TENNESSEE VALLEY AUTHORITY

WATTS BAR NUCLEAR PLANT (WBN) - VERTICAL SLICE REVIEW (VSR) PLAN

The purpose of this letter is to respond to those comments. The responses are numbered in enclosure 1 to correspond with the comments in your letter. The responses related to the VSR scope have been reviewed and concurred to by Sargent & Lundy.

Figure 01.01-1  
Sargent & Lundy Organization Chart  
01-2

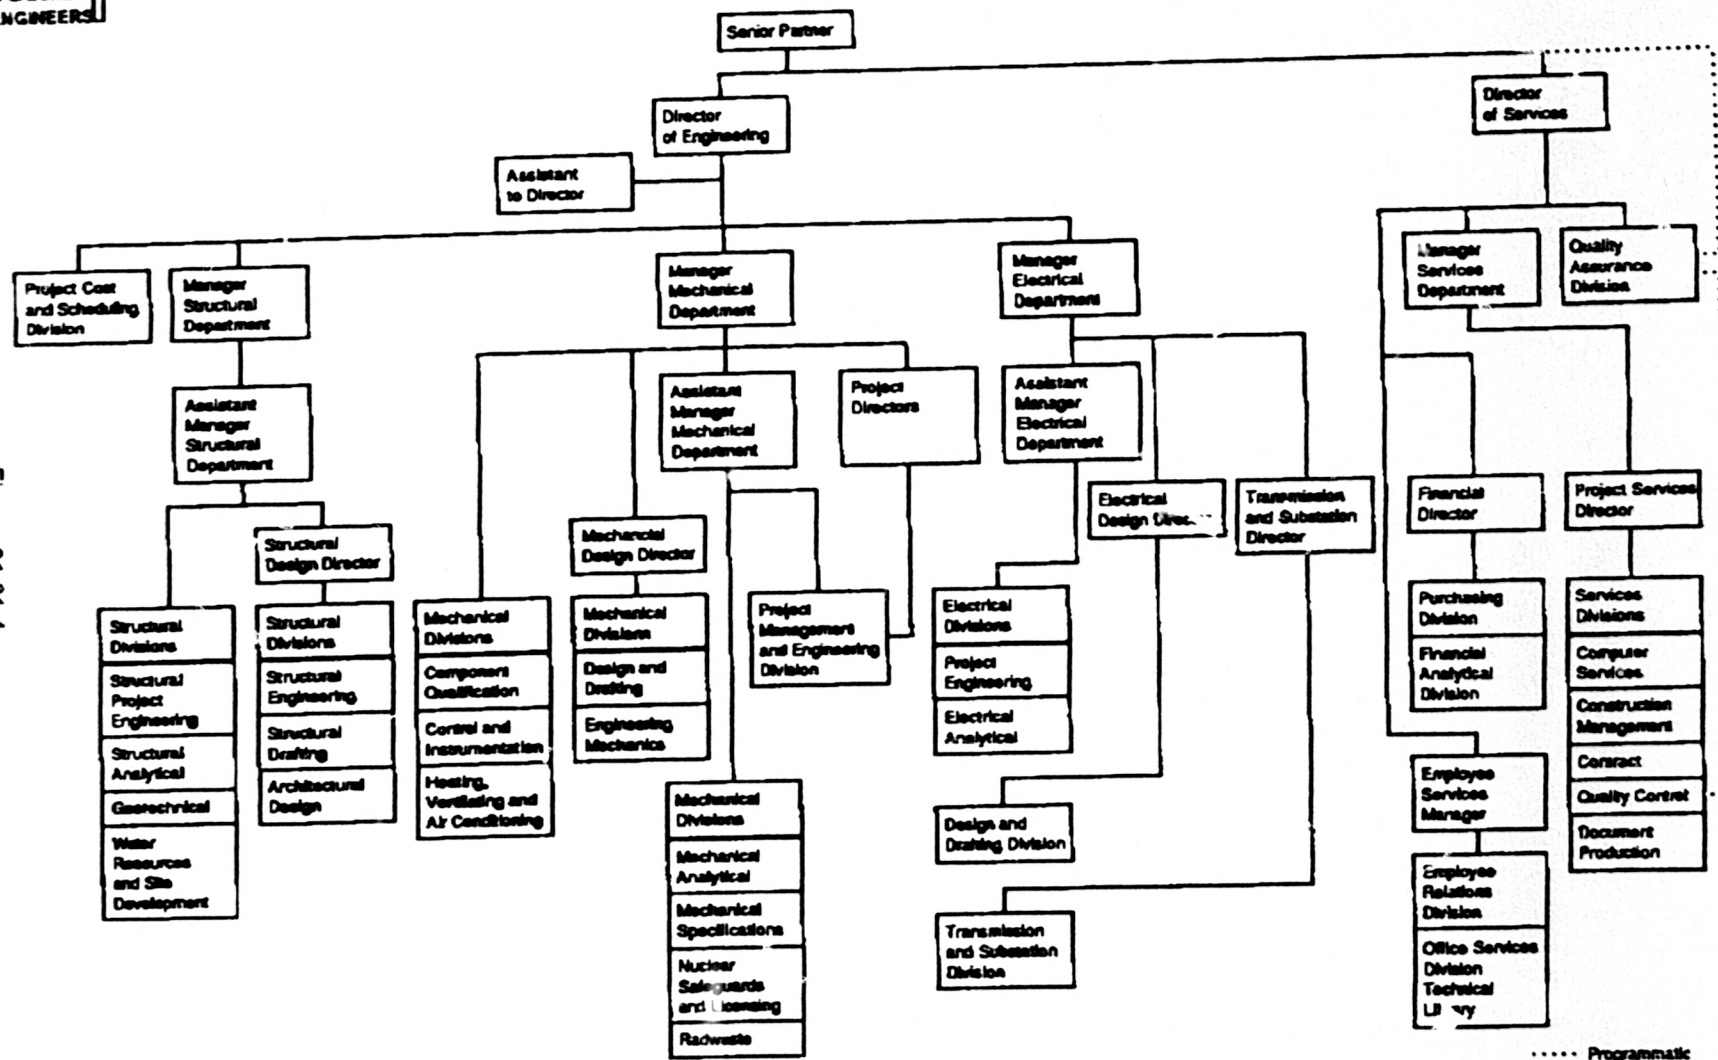
Section V - Who does the Head, Quality Assurance Division report to as described in the Quality Assurance Program for the VSR?

The head of Sargent & Lundy (S&L) Quality Assurance (QA) Division reports to S&L's director of services for QA activities in accordance with the S&L QA manual, as shown on the attached Figure 01.01-1, "Sargent & Lundy Organization Chart," from S&L Topical Report SL-TR-1A, revision 7.

**Exhibit IV-1**

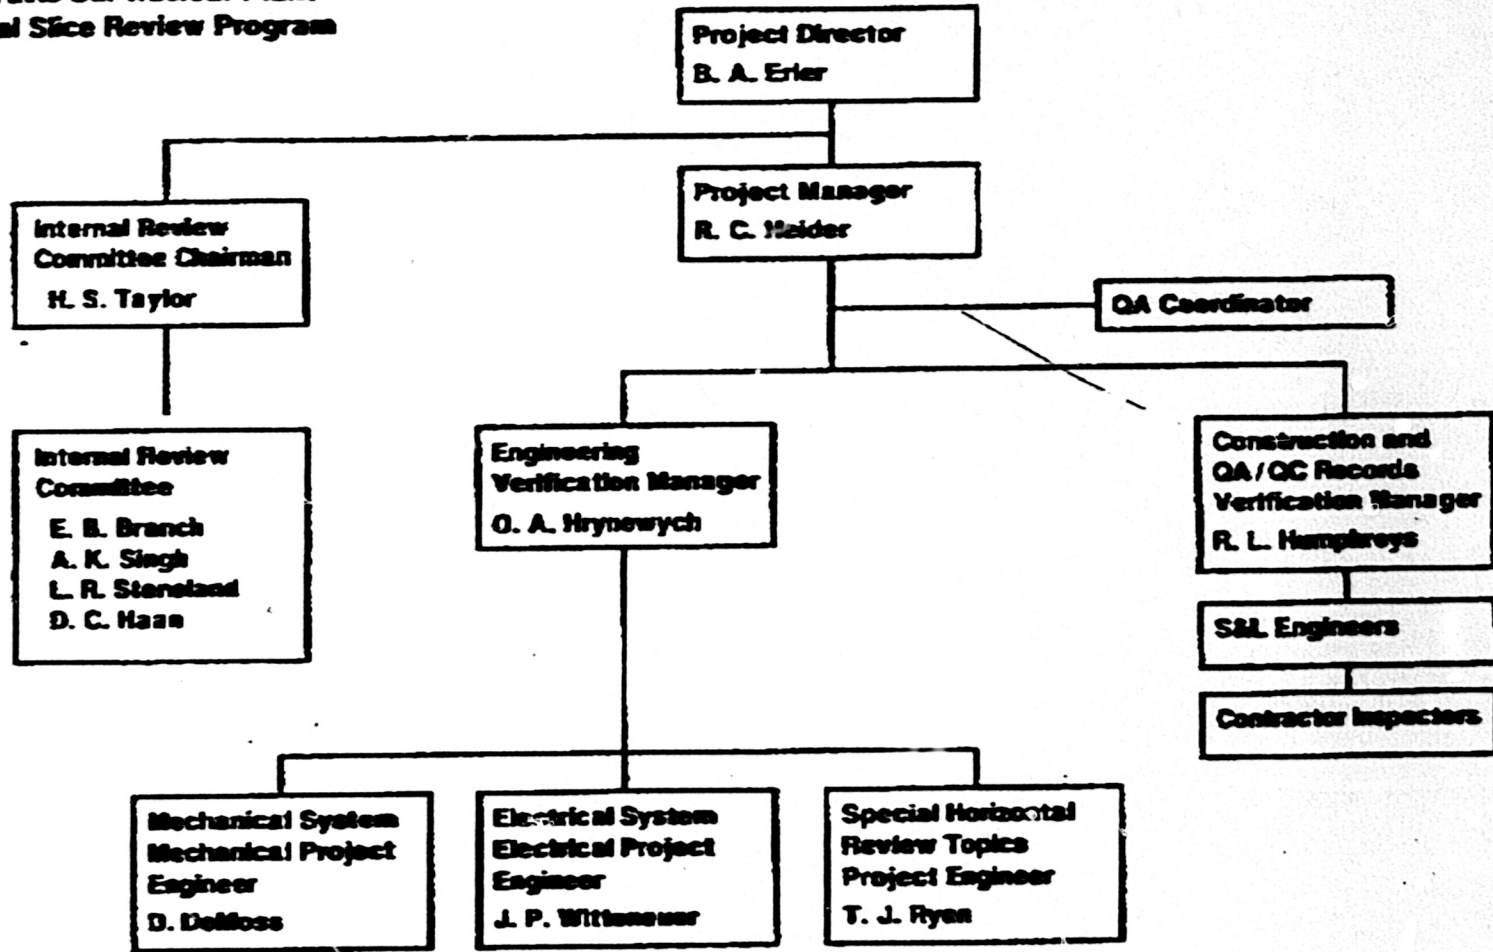
Section V - The Quality Assurance Coordinator reports to the Senior Quality Assurance Coordinator as described in Section 2.2.4. However, the Senior Coordinator does not appear on the organization chart (Exhibit IV-1). Where does the Senior QA Coordinator fit in the organization?

The QA coordinator in the VSRT reports to the project manager for project activities, as shown in the attached Exhibit IV-1. It should be noted that this exhibit, when originally submitted with the VSR plan to NRC, had an error in that it showed the QA coordinator reporting to the project director instead of project manager. Also, D. C. Haan (Internal Review Committee member) and J. P. Wittenauer (Electrical Project Engineer) have replaced R. L. Givan and T. M. McCauley, respectively, due to availability reasons. The exhibit does not show a senior QA coordinator because there is no senior QA coordinator on the project team. The QA coordinator reports to the senior QA coordinator for his non-VSR activities, e.g., administrative and technical direction, and the senior QA coordinator reports to the Head, QA Division, as shown on the attached Figure 01.02-1, "Quality Assurance Division Organization Chart," from S&L Topical Report SL-TR-1A, revision 7.
